**PROJECT** TAMU Equine Nutrition and Reproduction Facility, 2016192

**ADDENDUM NO.** 03

**NOTICE TO ALL BIDDERS**

**1 1D - ADD 2**  
 SK-4 E-124 1/8" = 1'-0"

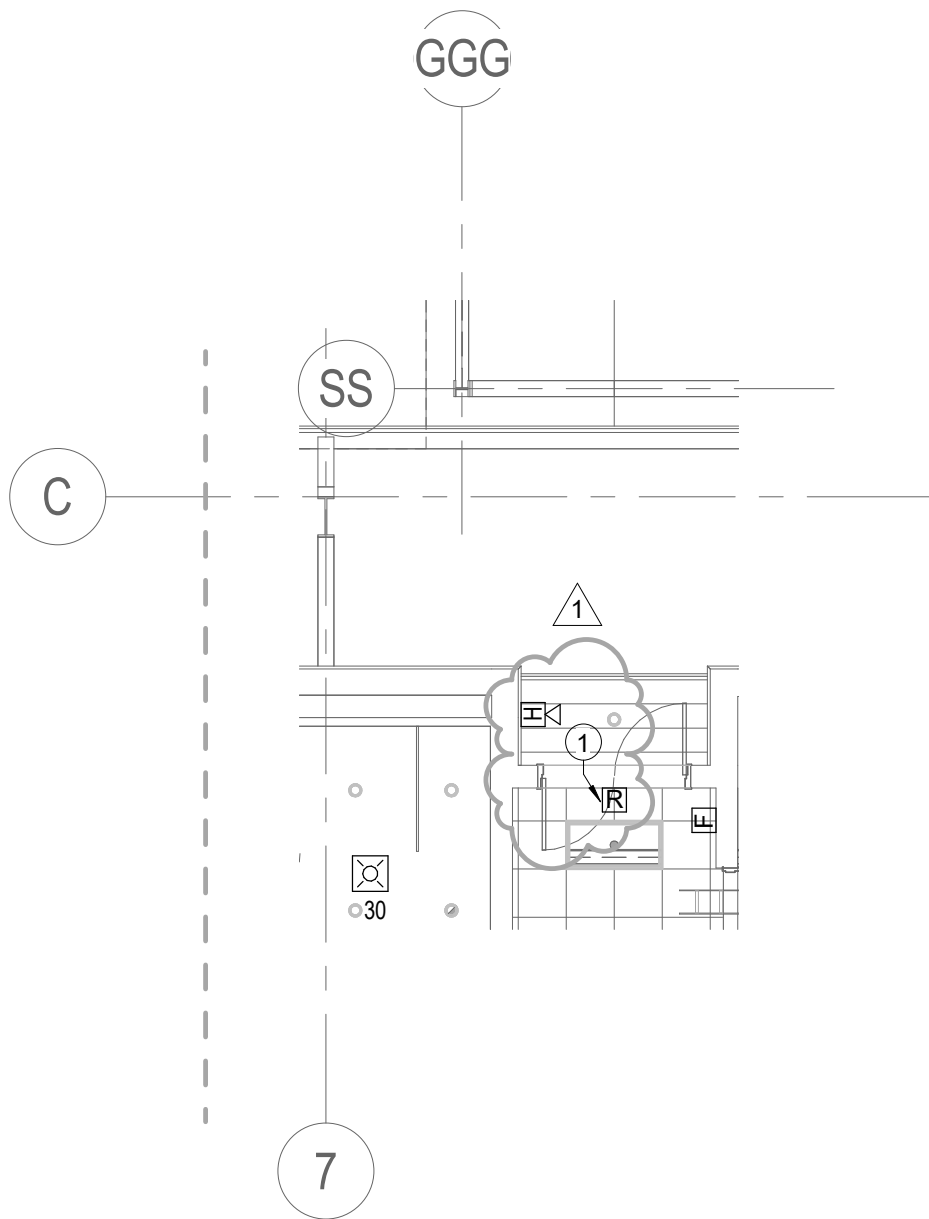
1 PROVIDE RELAY FOR MONITORING AND CONTROL OF MAGNETIC LOCKS FOR DOOR.
